APPLICATION FOR A CERTIFICATE OF APPROPRIATENESS – STAFF REPORT

165-17-CA      3227 BIRNAMWOOD ROAD  
Applicant:      ANN BROWN AND KENNETH KOHAGEN  
Received:      10/10/2017      Meeting Date(s):  
Submission date + 90 days: 1/8/2018      1) 11/27/2017    2)    3)

Raleigh Historic Landmark: PAUL AND ELLEN WELLES HOUSE

Nature of Project: Reconstruct retaining wall; construct driveway retaining walls; reconstruct walkway and stair; install fence; alter existing garage; install new windows and skylight; expand screened porch; alter rear deck; construct two-story addition with screened porch

3227 Birnamwood - New Site Plan (highlighting new site walls + areas of brick walk to be rebuilt)

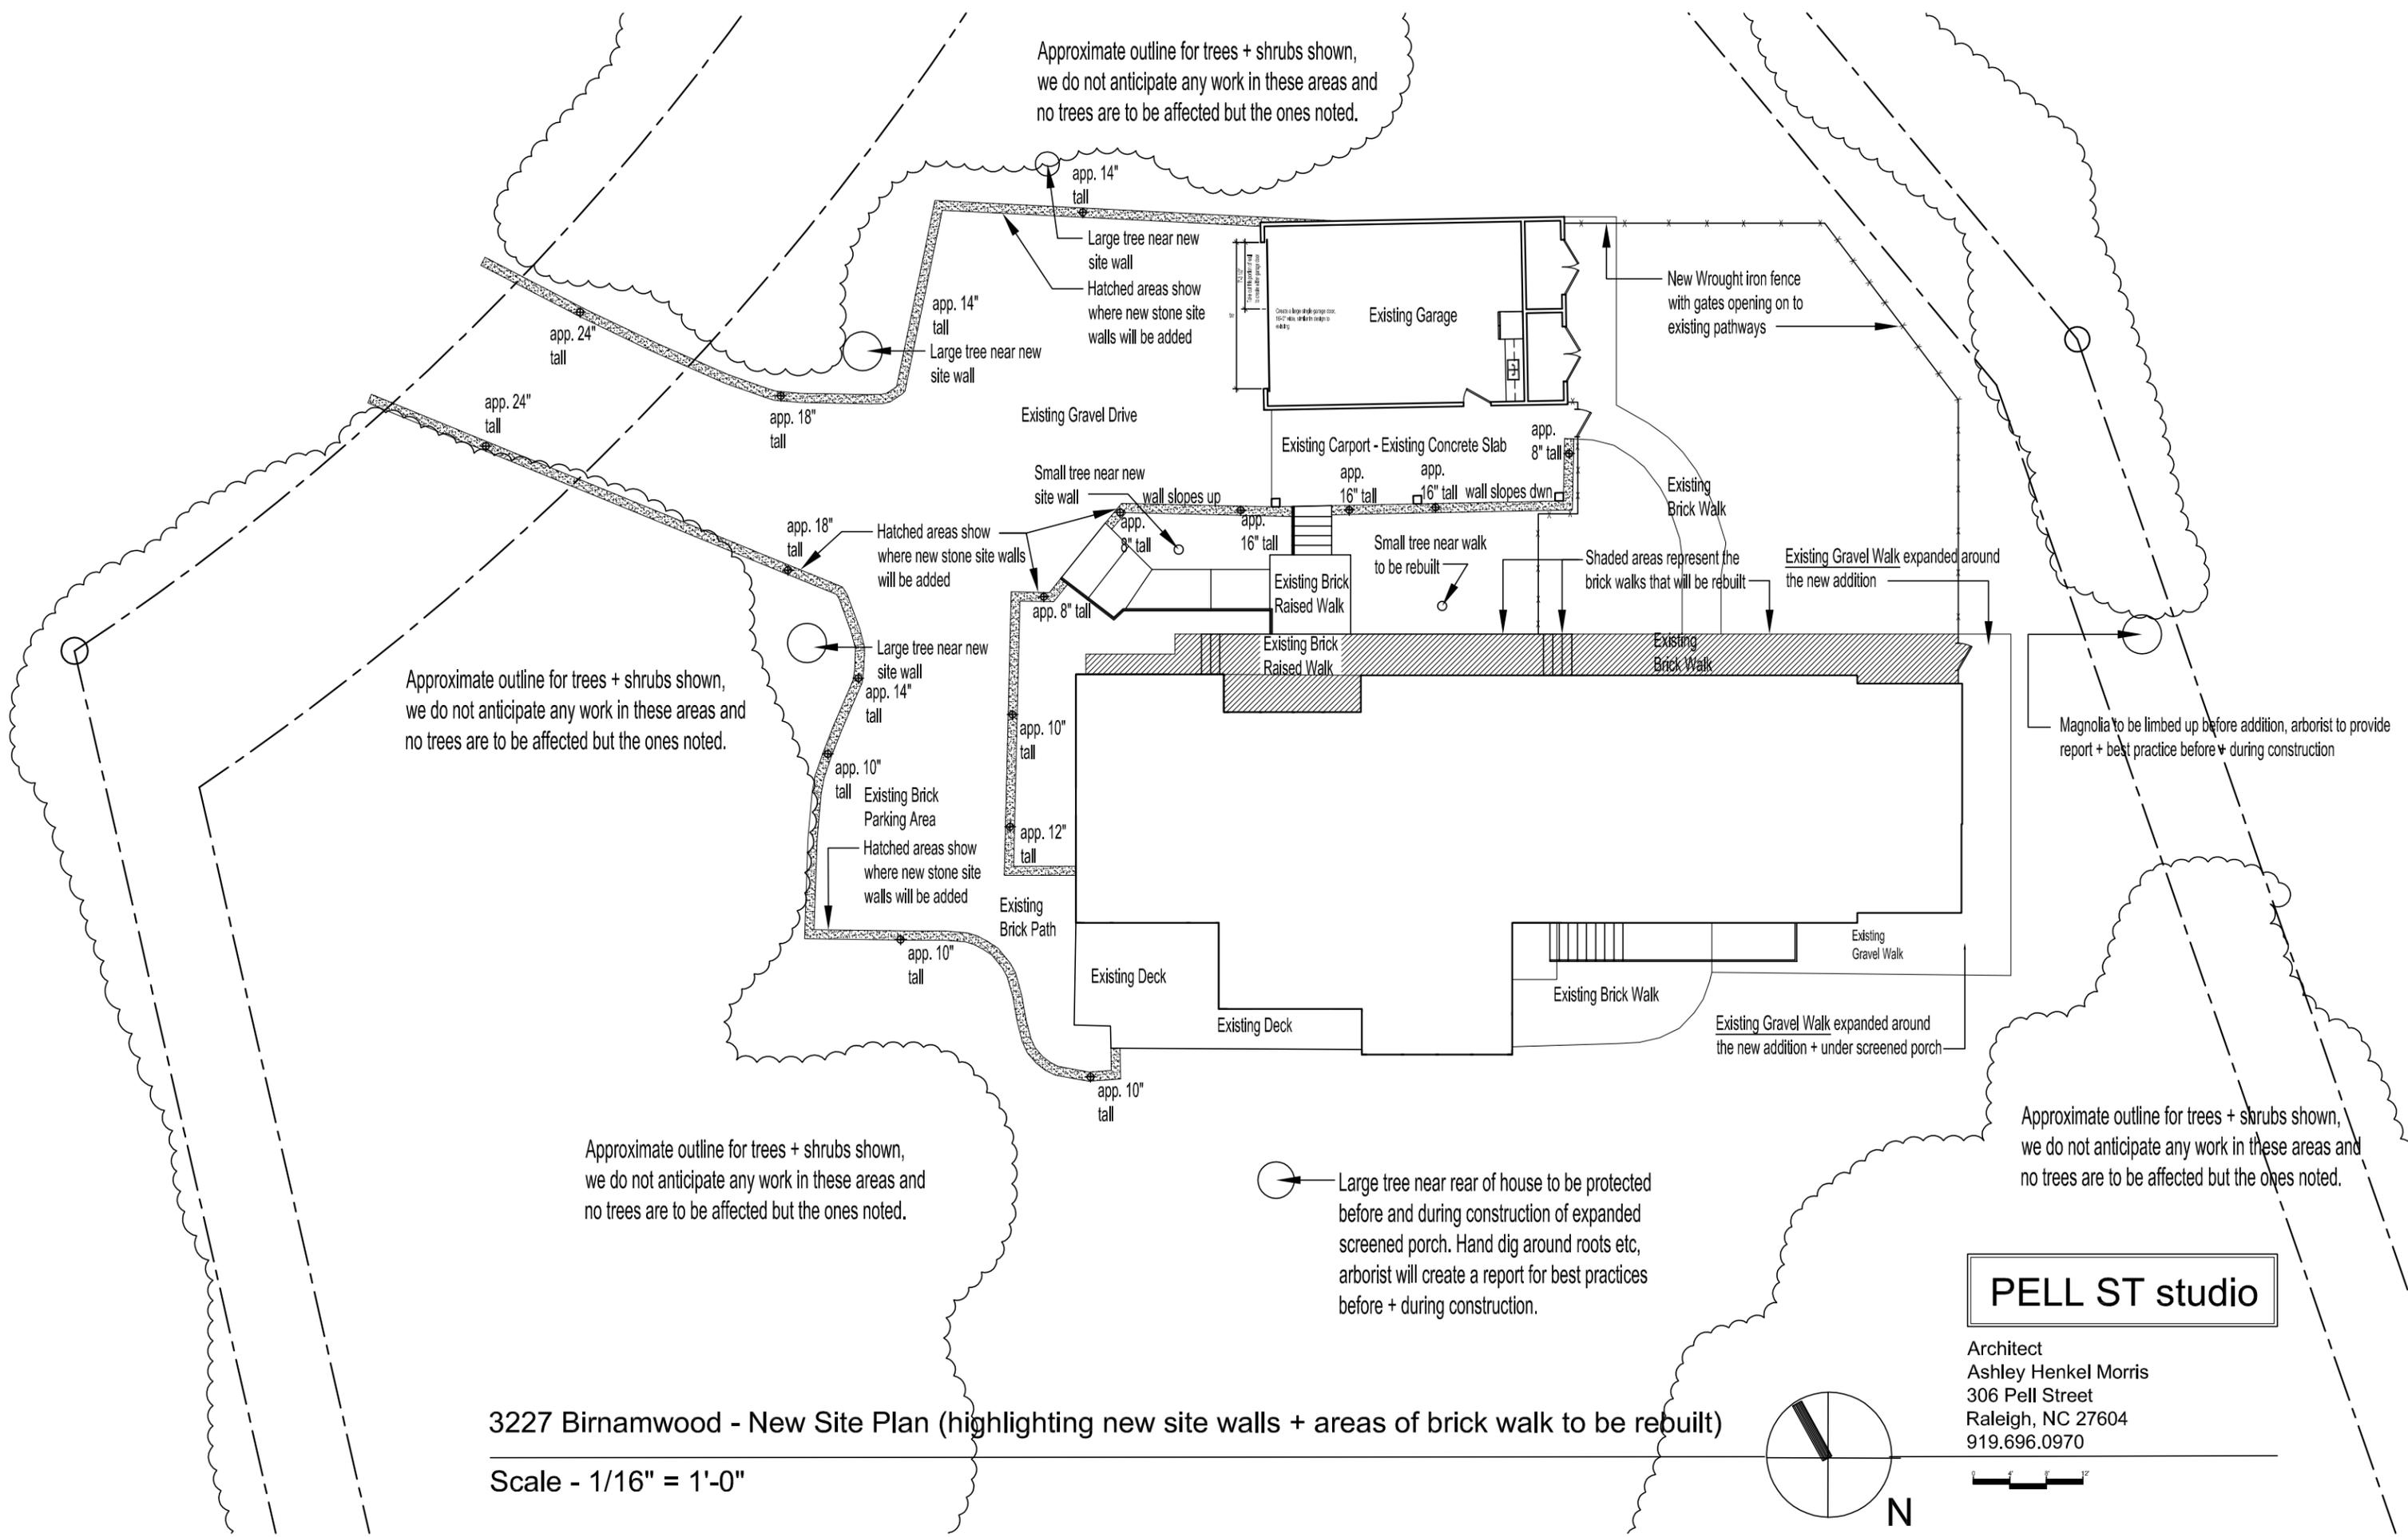
- 8\* There is a discrepancy between the stone site walls section drawing and the tree protection plan drawing. The wall section shows a portion of the wall being constructed below grade, while the tree protection plan states “stone site walls to be hand built on grade with no excavation within the critical root zone of large trees.”
- 9\* A 42” wrought iron fence is proposed for the east side of the lot connecting the eastern corner of the house with the far corner of the garage. Two gates are proposed. The design of the fence was provided but not of the gates.
- 10\* An existing wrought iron railing aligns with the wide stairway from the driveway to the front door.

1. As of right now we are only requesting to rebuild the existing raised brick walk + retaining wall, adjoining steps, and the lower brick path on grade. The areas of rebuild are hatched in the new built site plan. We are also requesting to build new low site walls to help start informing the entry and driveway. See attached plans, site wall section, info on why the site walls proposed are in keeping with the design principles of Mid-Century Modern and photographs of other noted Mid-Century modern houses in Raleigh with site walls. A more indepth landscaping plan will be created for a future phase and submitted under its own COA application. Revised site plans + tree protection plan are 11x17s

3227 Birnamwood - New West Elevation

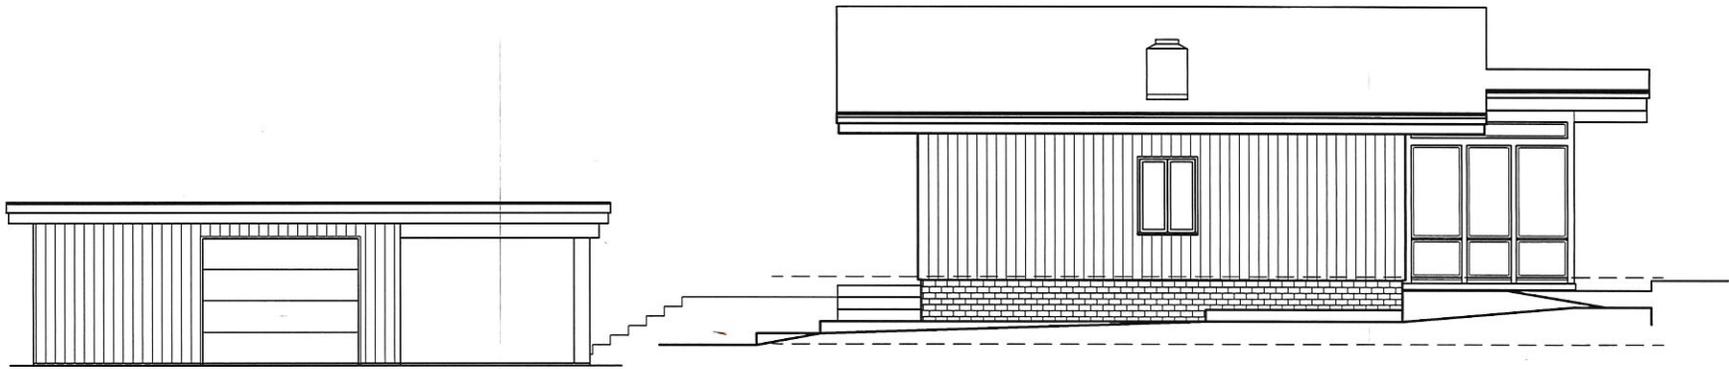
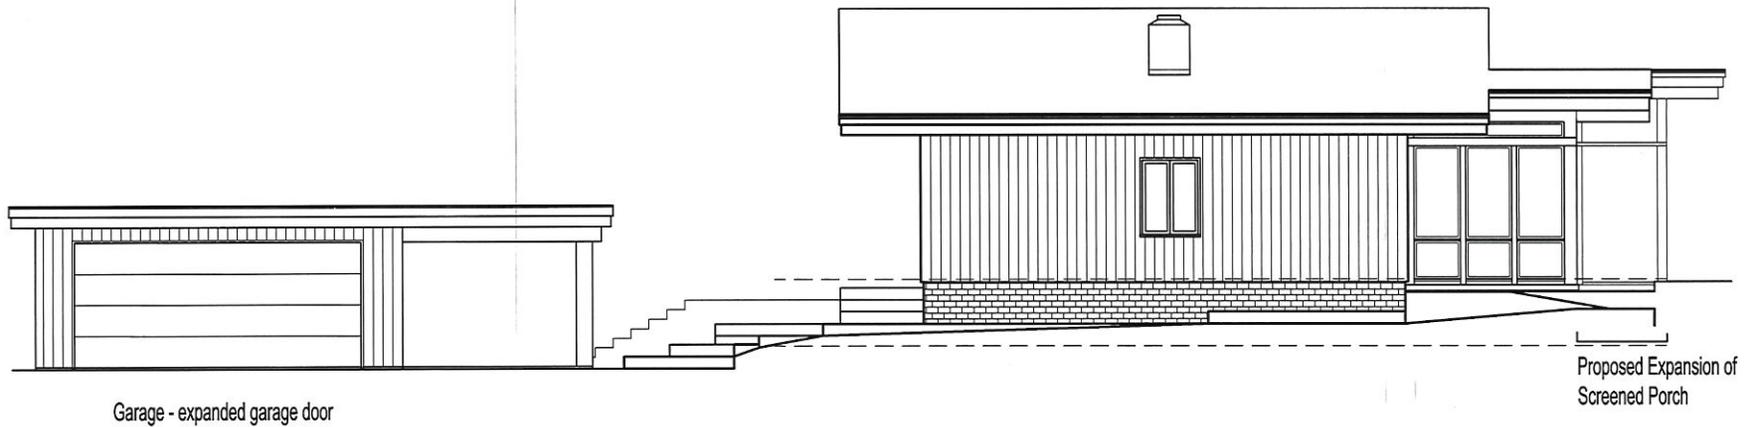
- 3\* The only change proposed to the garage is widening the vehicular door from 8’ to 16’. The elevation drawings show a similar design for the new door, but no door specifications were provided for the vehicular door.
